Project	IEEE 802.16 Broadband Wireless Access Working Group < http://ieee802.org/16 >	
Title	Comments on Zone Switch based Handover Procedure for IEEE P802.16m/D2 (15.2.6.4.1.2.1)	
Date Submitted	2009-11-06	
Source(s)	Yih-Guang Jan, Yang-Han Lee, Hsien-Wei Tseng, Ming-Hsueh Chuang, Jheng-Yao Lin Tamkang University (TKU)	yihjan@yahoo.com
	Youn-Tai Lee, Chun-Yen Hsu Institute for Information Industry (III)	lyt@nmi.iii.org.tw
	Shiann-Tsong Sheu National Central University (NCU)	stsheu@ce.ncu.edu.tw
	Whai-En Chen National Ilan University (NIU)	wechen@niu.edu.tw
Re:	IEEE 802.16 Working Group LB30a: P802.16m/D2	
Abstract	Comments on Zone Switch based Handover Procedure for IEEE P802.16m/D2 (15.2.6.4.1.2.1)	
Purpose	To be discussed and adopted by TGM for IEEE P802.16m/D2.	
Notice	<i>This document does not represent the agreed views of the IEEE 802.16 Working Group or any of its subgroups. It represents only the views of the participants listed in the "Source(s)" field above. It is offered as a basis for discussion. It is not binding on the contributor(s), who reserve(s) the right to add, amend or withdraw material contained herein.</i>

Comments on Zone Switch based Handover Procedure for

Figure 410— Handover procedure from WirelessMAN-OFDMA BS to ABS: the T-ABS instructs AMS to switch zone after completion of network reentry at LZone

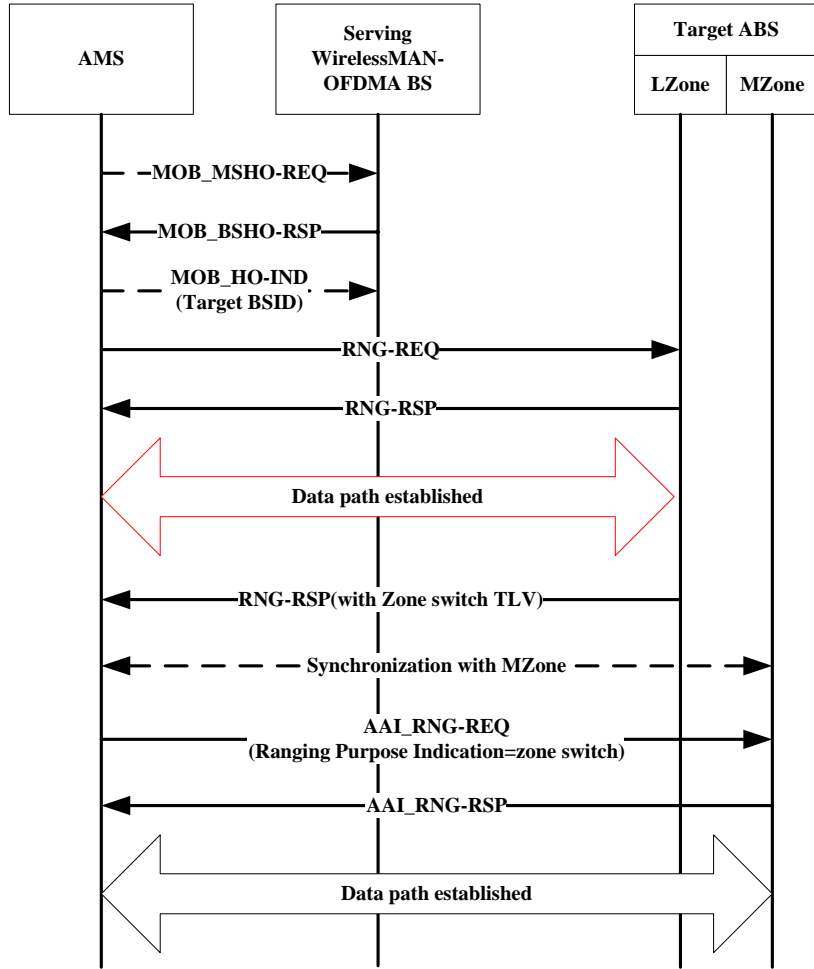
This contribution provides the corrected figure in the description of Zone Switched based Handover Procedure. It has an error in the description of 'Data Path Established' in Figure 410.

[In IEEE P80216m/D2, Section 15.2.6.4.1.2.1, replace Figure 410 by the following corrected figure]
